# CITY OF TEMPE DEVELOPMENT REVIEW COMMISSION

**ACTION:** Request a Development Plan Review for a new 5,500 square-foot commercial building for TEMPE CROSSINGS 2 LOT 1, located at 9895 South Priest Drive. The applicant is Paradigm Design.

DPR200048 Development Plan Review including site plan, building elevations, and landscape plan

This project was processed through one (1) preliminary interdepartmental site plan review (March 11, 2020) and two (2) interdepartmental site plan reviews after a formal application (April 29, 2020 and June 10, 2020). The following items, listed by category, were requested by staff (in italics) and addressed by the applicant as follows:

LOT 1 SITE PLAN WITH OVERALL SITE PLAN SP-2

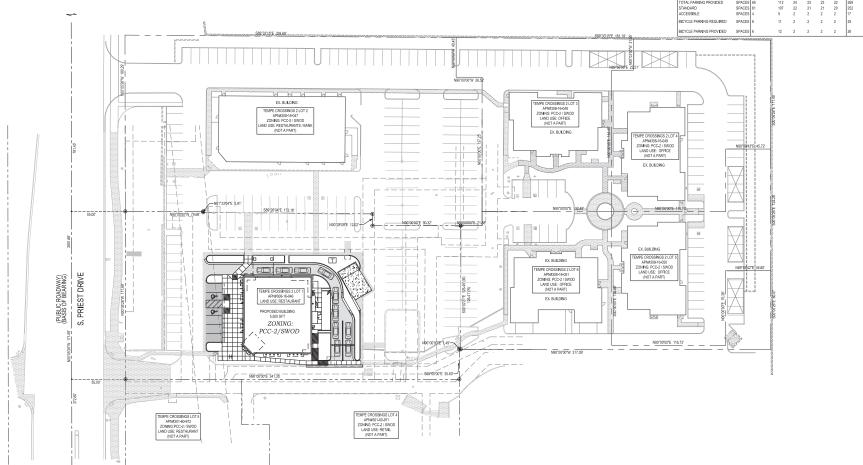
- a. Planning Staff recommended a drive-through canopy over the pick-up window along the north elevation; the applicant accommodated this comment by providing a generously sized canopy with architecturally matching support columns.

- b. Planning Staff recommended a delineated ADA path from the ADA parking stalls located north of the drivethrough to the building's main entrances; the applicant accommodated this comment.

- c. Staff recommended shade canopies over potential patio areas along the west storefront with patio railing should either tenant ever pursue a Series 12 liquor license; the applicant added canopies over the doors and windows but did not provide patio railing. Staff has no concerns since each tenant is unique and may prefer different design options depending on their business models and needs.

- d. Solid Waste Services requested a double refuse enclosure with proper dimensions, turn radii, and refuse truck maneuvering area (approach and backup distances); the applicant accommodated this request by increasing the refuse enclosure size from a single to a double enclosure, and relocating it to a more accessible area of the site. Solid Waste Services has no concerns with the modifications.

LANDSCAPE PLAN LS-1

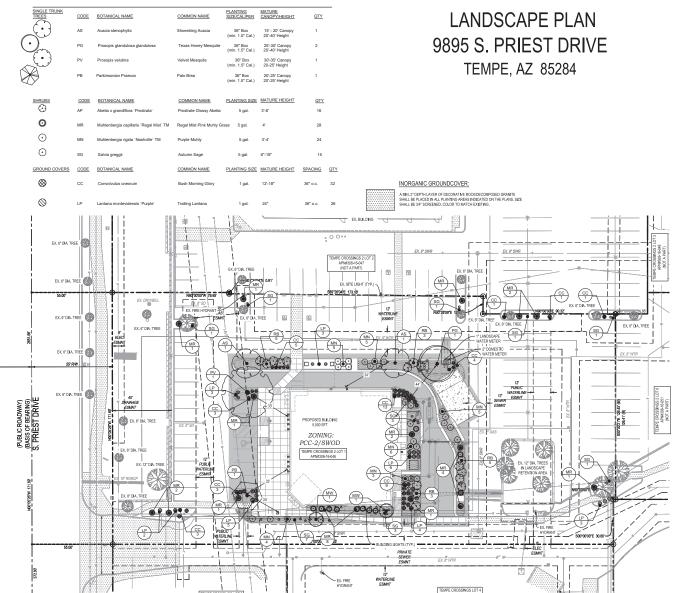
- a. Planning Staff recommended a plant palette that is consistent or complimentary to the original development; the applicant accommodated this comment.
- b. Planning Staff recommended reducing the north parking drive aisle width to the minimum standard to accommodate a wider landscape strip for healthy tree growth; the applicant accommodated this comment.
- c. Staff recommended 60% vegetative ground cover within all landscape areas; the applicant accommodated this comment.

A200

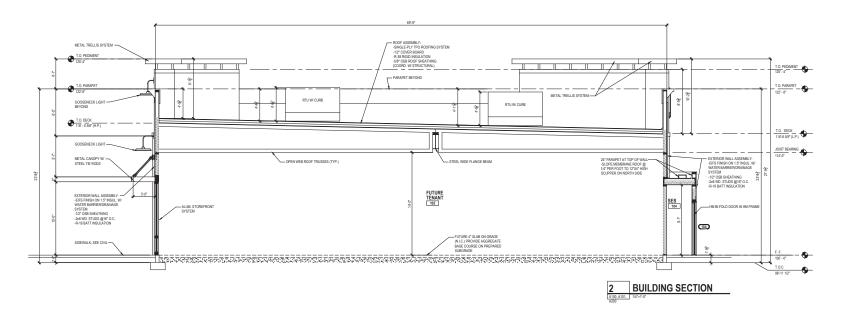
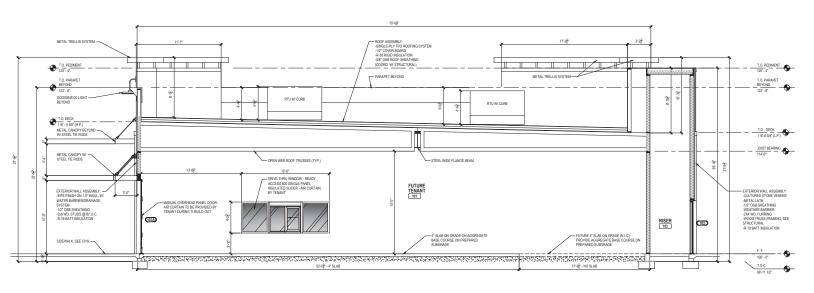
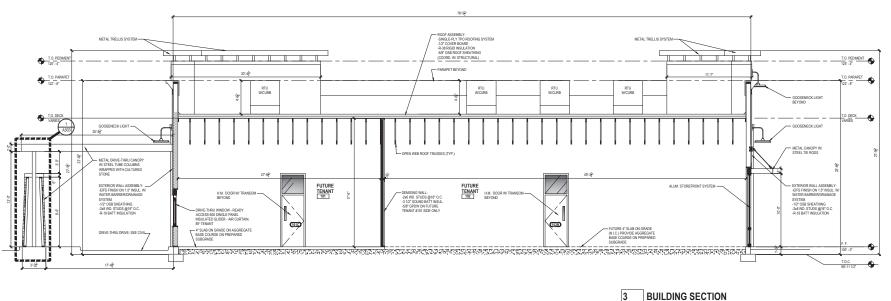
- a. Planning Staff recommended a design that matches buildings of the commercial complex (north and east of project site) in terms of materials & finishes as well as form such as the trapezoidal shape of tower elements and support columns; the applicant revised the plans to reflect the form comment but kept the proposed color scheme since it provided a modern take of the complex's original design. The applicant believes the rest of the center will follow suit whenever the time comes to renovate. Staff has no concerns with the applicant's response since the form will match and the proposed materials & finishes complements the complex's design.

- b. Planning Staff recommended integrating the SES and fire riser into the building area; the applicant decided to architecturally integrate the utility rooms as building pop-outs rather than reduce the amount of the commercial net floor area. Staff has no concerns with the applicant's response since the pop-outs are architecturally integrated and located at the rear of the building away from the street.

- c. Planning Staff recommended removing or reducing the amount of gooseneck lamp accent lighting; the applicant did not accommodate this comment. Staff has no concerns with the applicant's response.
